NUCLEAR POWER

Response to Environmental Permitting Regulations 2016 Schedule 5 Notice, Issued 11/12/2018

Application number: PAN-002427

Document Number: HNP-HZCON-PAC-REP-00011

Absolute Temperature, surface (16.7 °C baseline)

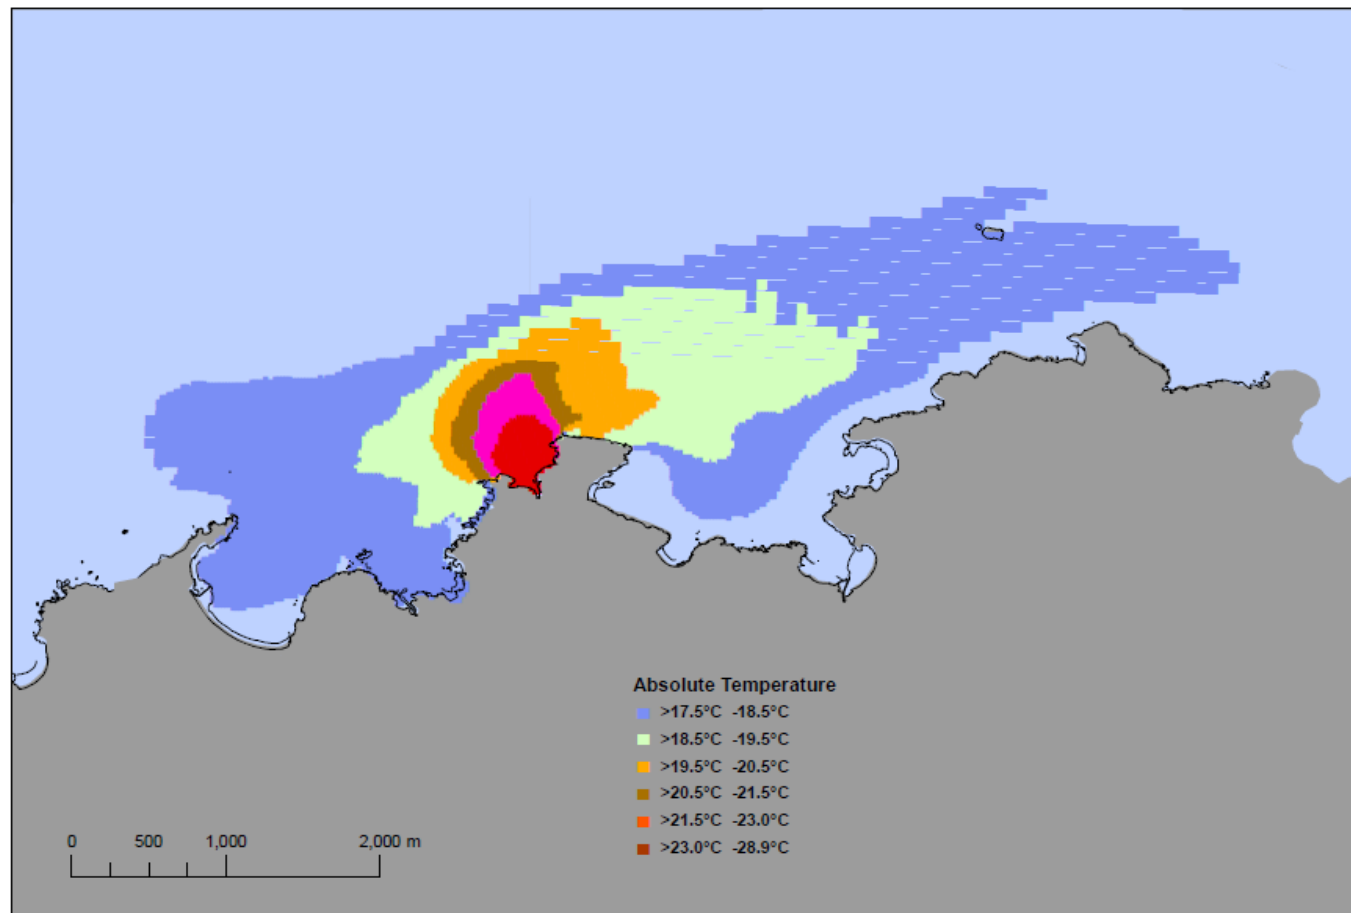
1.1 We note that for the 23°C absolute temperature target mixing zone, the hydrodynamic model uses a background temperature of 16.44°C. You have produced further statistical modelling (WYL-PD-PAC-REP-00012, Appendix G) using more up-to-date data (1993 to 2013 or 2003-2012) where the 98%ile is 16.6°C or 16.7°C, respectively. Using the more up to date data could impact on the areal extent calculated for absolute temperature / mixing zone. Provide the areal extent for absolute temperature/mixing zone using the up to date data.

1.1 Updated absolute temperature figures for surface and bed are provided below. The 23 °C mixing zone areas are 0.14 km² and 0.01 km² at the surface and bed, respectively.

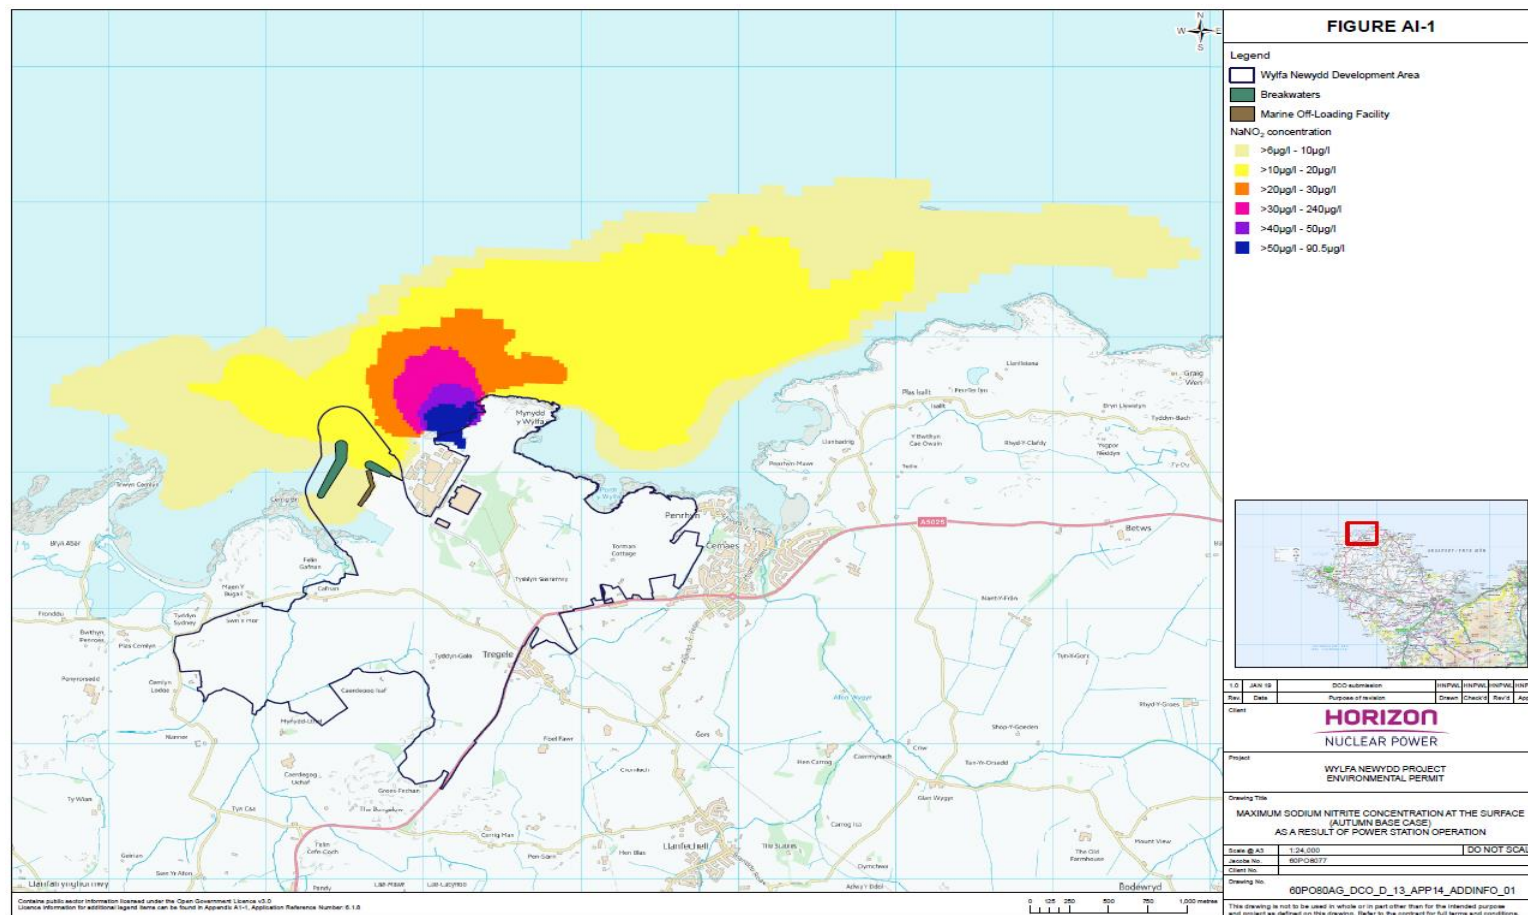
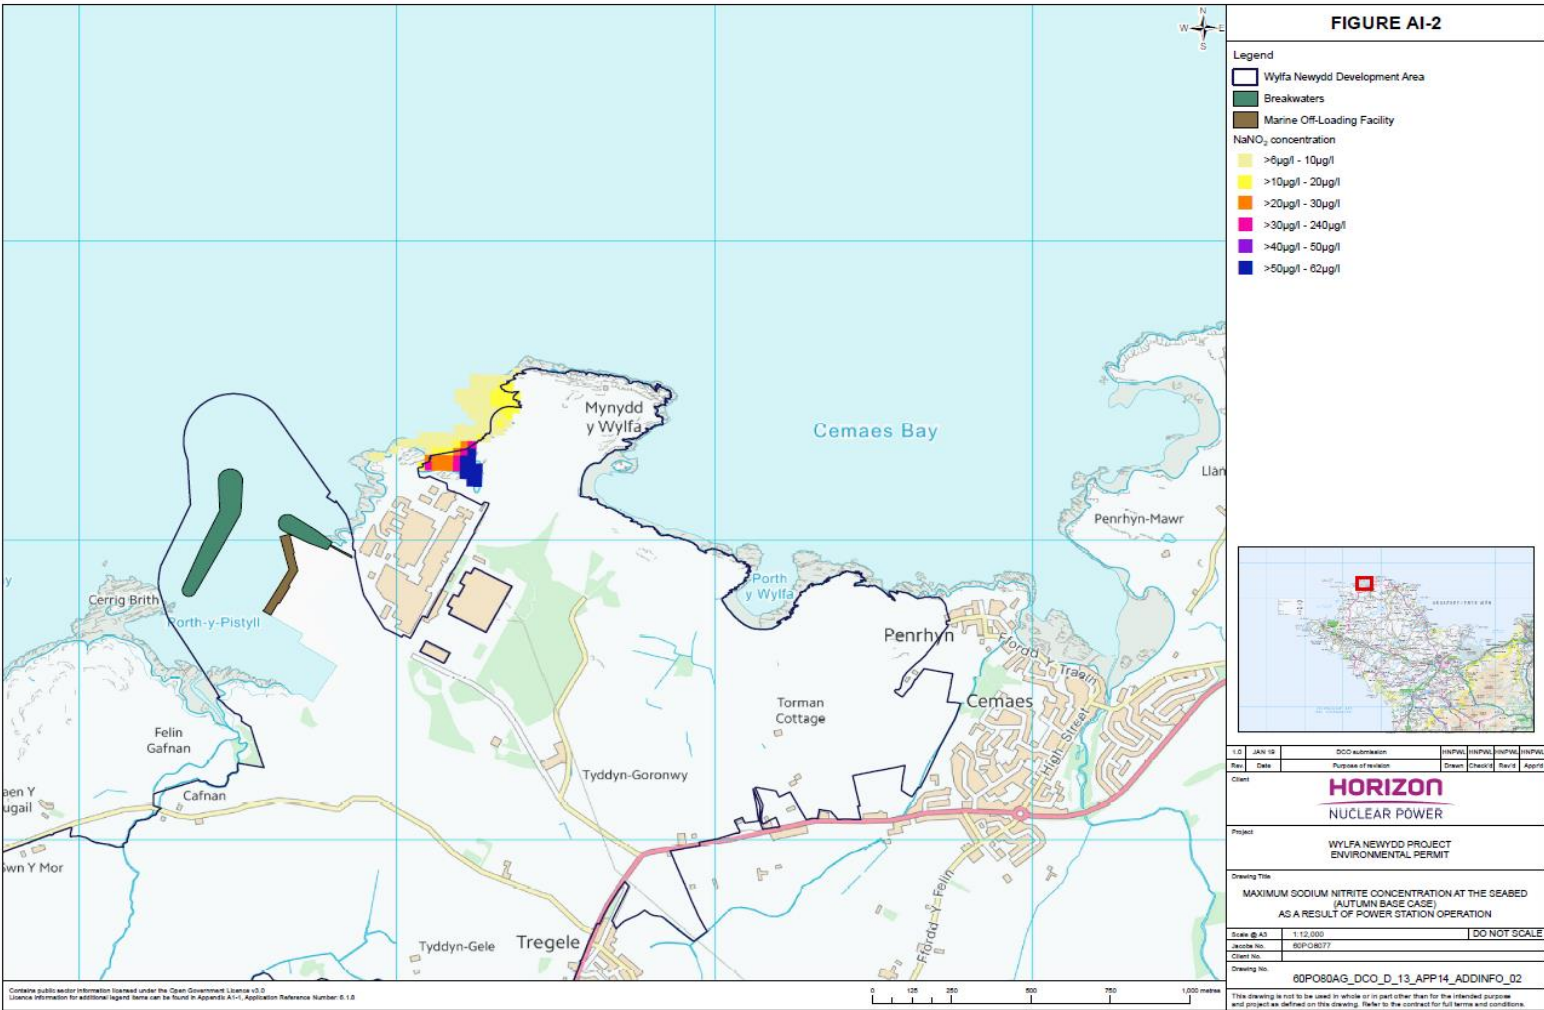
1.2.1 Provide worst case scenario to model the extent of the sodium nitrite.

1.2.1 Sodium nitrite modelling has been repeated using the autumn base case as a worst-case scenario. The outputs are provided below (surface figure AI-1 and bed figure AI-2); figures show the sodium nitrite mixing zone out to the Predicted No-Effect Concentration (PNEC) value of 6 µg/l.

1.2.2 Sodium nitrite modelling has enabled the area of the mixing zone for this case to be determined. This area equals 7.29 km² at the surface and 0.058 km² at the bed.

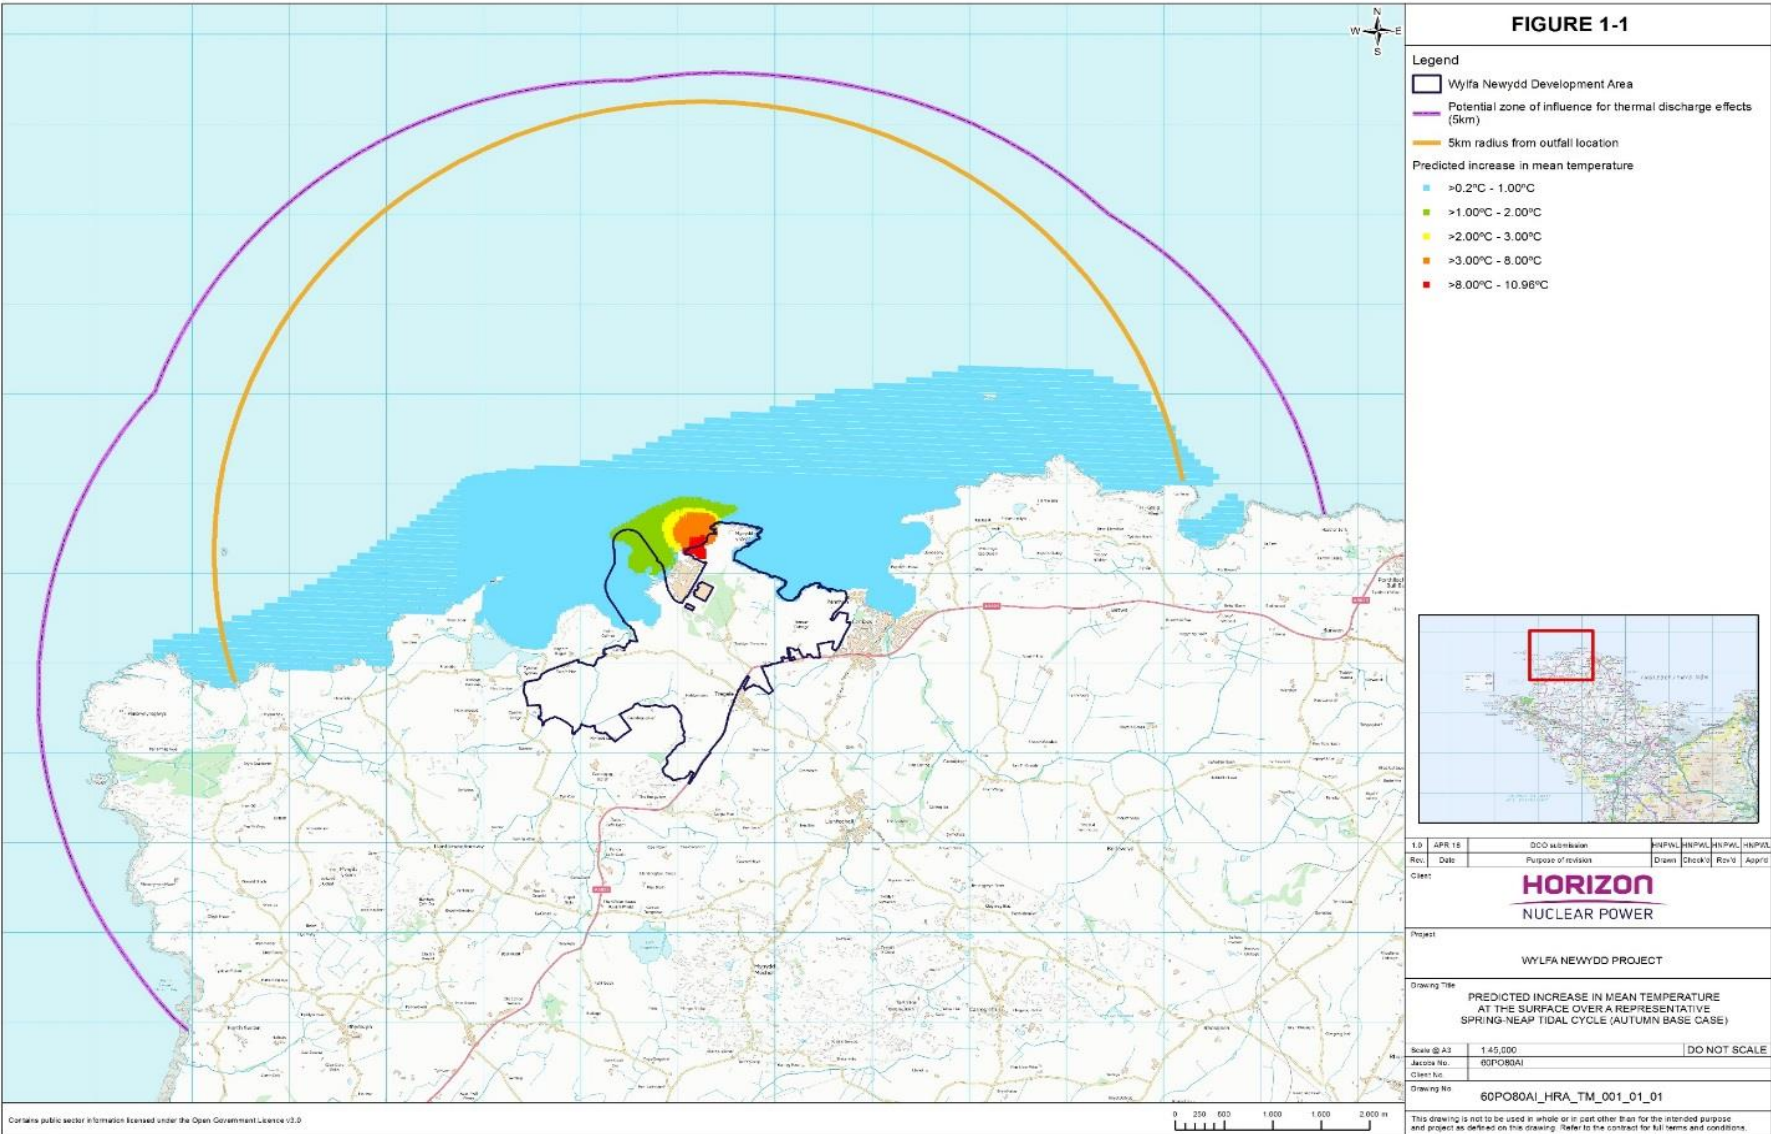
3.2.1 Provide a figure showing the modelled area of sea which is greater than or equal to 0.2 degree mean surface water temperature rise above the prevailing environmental condition (baseline).

3.2.1 The figure is provided overleaf (figure 1-1) showing this (Autumn base-case). Note that this figure has been produced previously and provided to NRW in pre-application discussions (May 2018), in Horizon memo ref. WN0908-JAC-PAC-TEC-00001, also provided with this response.

3.2.2 The area presented in the Autumn base case figure produced to address 3.2.1 equates to 14.40 km².
